## Cairn Homes Development - Castletreasure

### Road Safety Audit: Stage 1

April 2019

**Figure 9: Dangerous On-Street Parking**

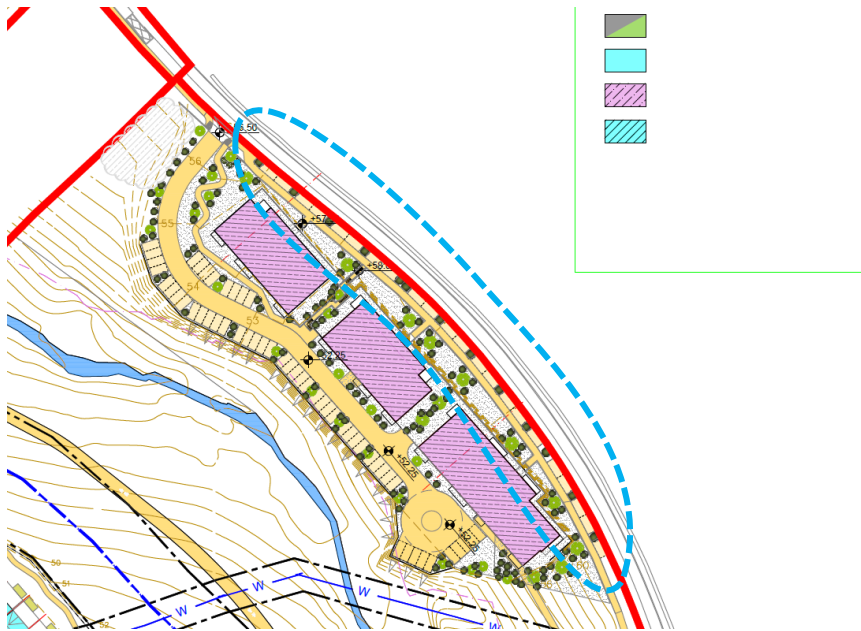
It appears that on street parking is to be provided along the Carrigaline Road for the north-eastern apartment blocks. Parked vehicles may present a road side hazard for drivers on the Carrigaline road, particularly when vehicles are manoeuvring in and out of the spaces. . Additionally, people exiting/entering parked vehicles are at risk of being struck by passing vehicles. Excessive speeds were observed along this road, further exacerbating the problem (See also problem 1.1).

The on-street parking should be relocated within the development and removed from Carrigaline Road.

3.3	No	No	This issue is linked to Item 3.1, a gateway entry treatment has been designed south of the junctions on the R609 to create a gateway/entrance to Douglas. This will alter the nature of the roadway from rural to urban.  DMURS encourages on street parking to help reduce speed of vehicles along with the additional gateway entry treatments, warning signage, street lighting and road markings etc. The parking spaces are 2.5m x 5m with an additional 500mm setback from the road edge. There is also a 2m path inside the spaces.	Yes

**Figure 11: Vehicle Priority (source: Google maps and annotation by JB Barry)**

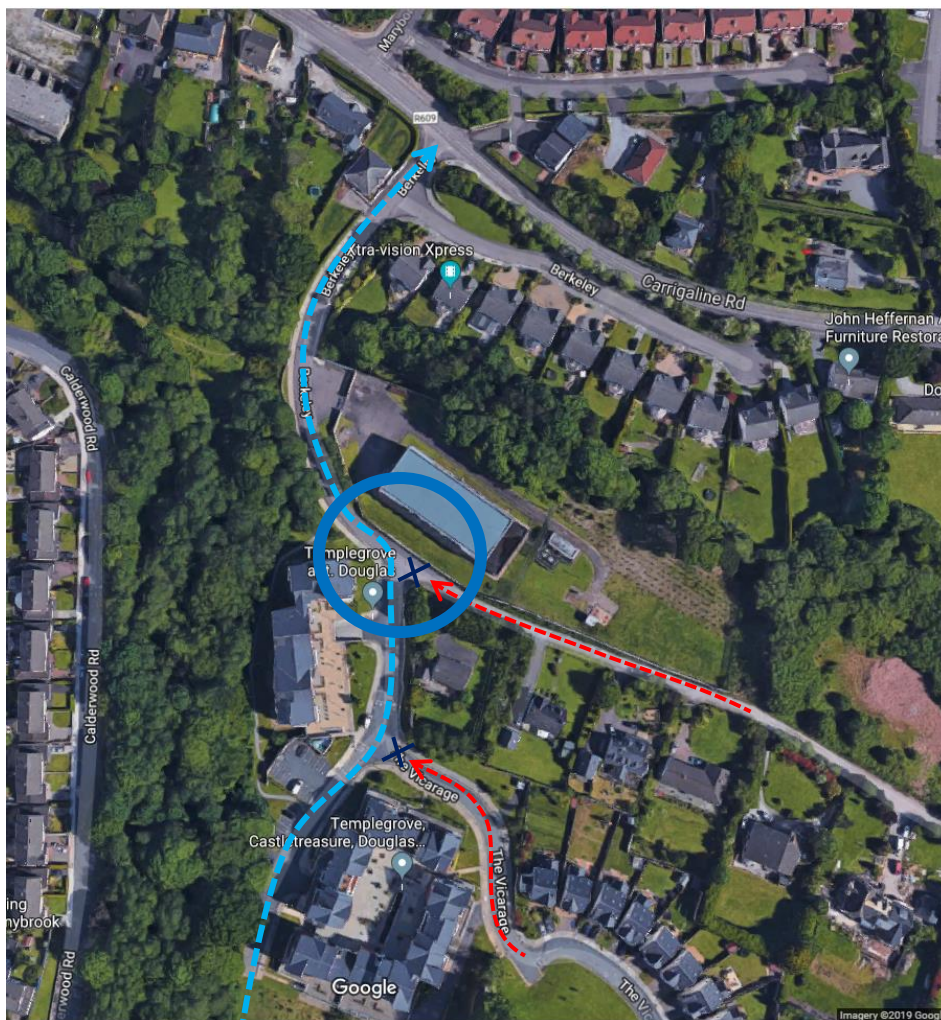
Currently along the secondary access route via Berkley road and Templegrove, priority is given to Berkley road and Vicarage road..

Sightlines at the junction of Berkley Road and Templegrove, for vehicles traveling from Templegrove (and the proposed development) are limited.

With very low volumes using the other roads along this route, vehicles traveling from the development will assume a priority and will not be expecting vehicle movements from The Vicarage or Berkeley. This behaviour will result in conflicts and an increased likelihood of vehicle collisions.

Review the priority at on this access route to provide for the dominant flow of traffic. Stop Signs and Stop Road Markings should be introduced to confirm priority.

Sightlines/Visibility commensurate with the operational speed of the road should be provided.

3.4	Yes	Yes - This will be reviewed in consultation with the Management Company for the estate.		
3.5	Yes	Yes - This will be reviewed in consultation with the Management Company for the estate.

**Figure 13: Potential location for pedestrian crossing**

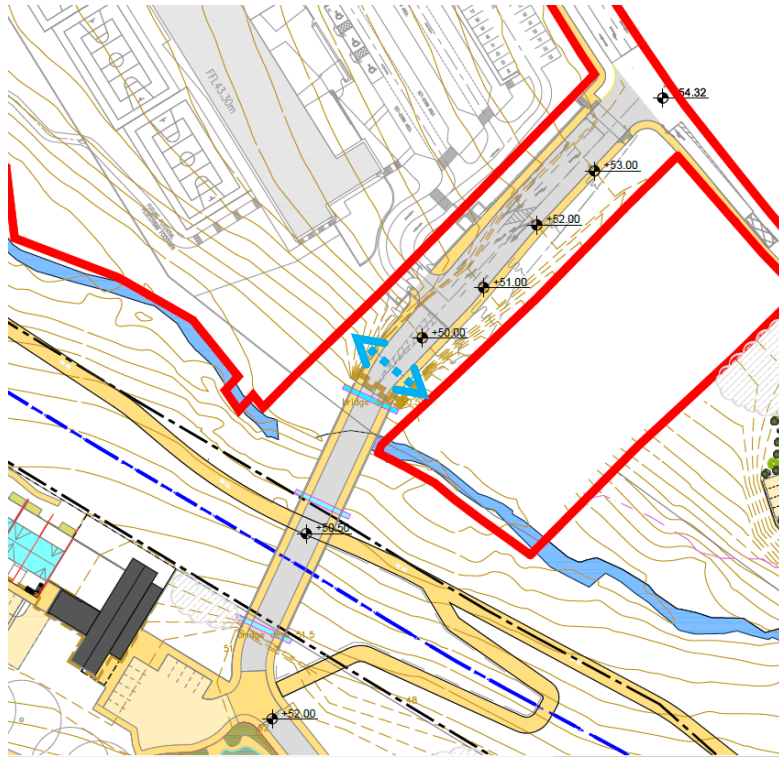
No pedestrian crossings have been provided to the west of the school. A crossing at this location would be on the desire line for pedestrians/cyclists coming to/from the proposed development and the proposed greenway to/from the new school. In the absence of a crossing, pedestrians will likely cross at an unsafe location resulting in possible conflicts with vehicles.

Provide a pedestrian crossing (raised table) to the west of the school.

3.6	No	No	The raised table (uncontrolled crossing) at the creche junction is close to the proposed location for a pedestrian crossing. There is no real destination on the eastern side of the carriageway, and we feel people will have crossed to the western footpath at the creche junction. This will be designed to accommodate pedestrians crossing at detailed design stage.	Yes

**Figure 14: Sample parking locations close to junctions**

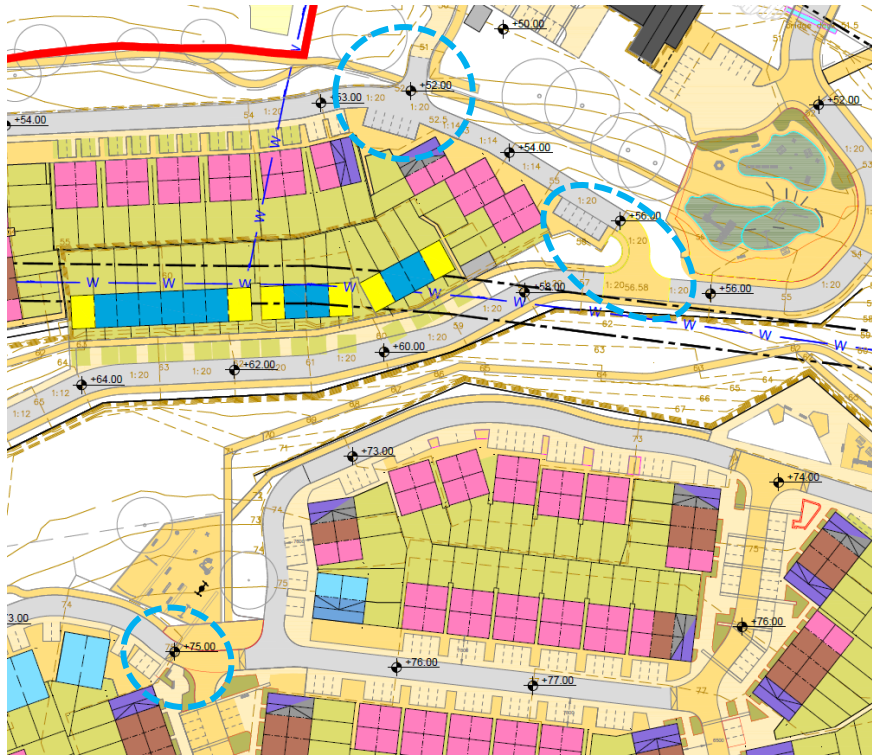
At a number of locations throughout the development, residential parking bays are situated adjacent junctions. Vehicles will have to reverse into the adjacent junction, increasing the likelihood of collisions with other vehicles entering the junction.

Relocate the parking bays away from the junctions.

3.7	Yes	No	The proposed site layout has been designed in accordance with DMURS to encourage a more pedestrian friendly environment within the development.  Raised tables are proposed at junctions to reduce speed; we propose to increase the raised table at the main junction highlighted to extend to the parking bays highlighted and to introduce another raised table at the second junction highlighted.	Yes

**Figure 15: No turning head**

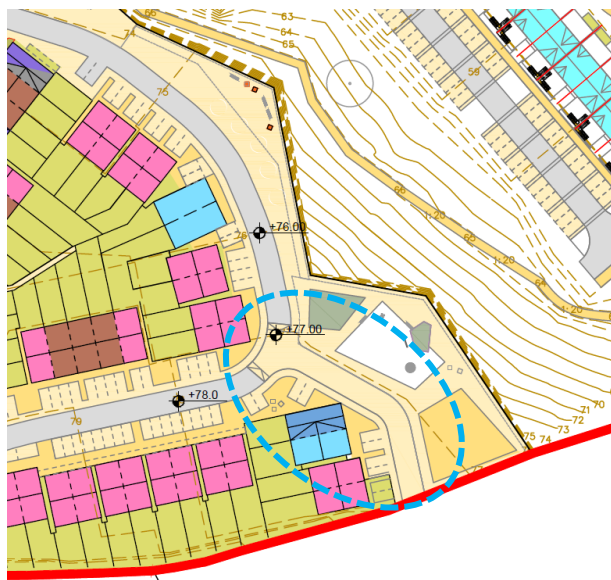
The cul-de-sac at the south-eastern corner of the development is missing a turning head. This will result in an increase in complex reversing manoeuvres, and an associated increased risk to vulnerable road users.

Whilst it is noted that turning heads may not be required for short cul-de-sacs, a turning head should be provided for the longer more complex cul-de-sacs such as the one in Figure 15. Turning heads will minimise the requirement for vehicles, particularly larger goods or refuse vehicles, having to reverse long distances.

3.8	No	No	This is a short spur, cul de sac serving 4 no dwellings with a raised surface and play areas.  A turning area is not required in our opinion.	Yes

**Figure 16: Sample obstructed visibilities**

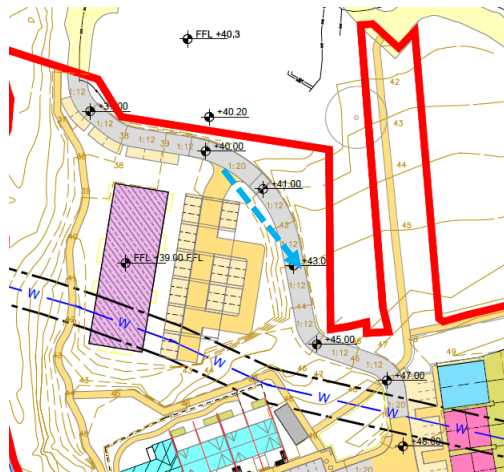
The internal junction for an apartment block along the southern access route is located on a bend. It is unlikely that sufficient visibility will be available for vehicles using this junction.

Insufficient visibility at junctions could lead to vehicles turning into oncoming traffic leading to side swipe collisions and rear end shunts.

Sightlines/visibility commensurate with the operational speed of the road should be provided at all junctions.

3.9	No	No	The access junction to the apartment highlighted is within a 30kph road zone, under Table 4.2 of DMURS forward visibility of 23m are required.  This is provided at this junction.	Yes
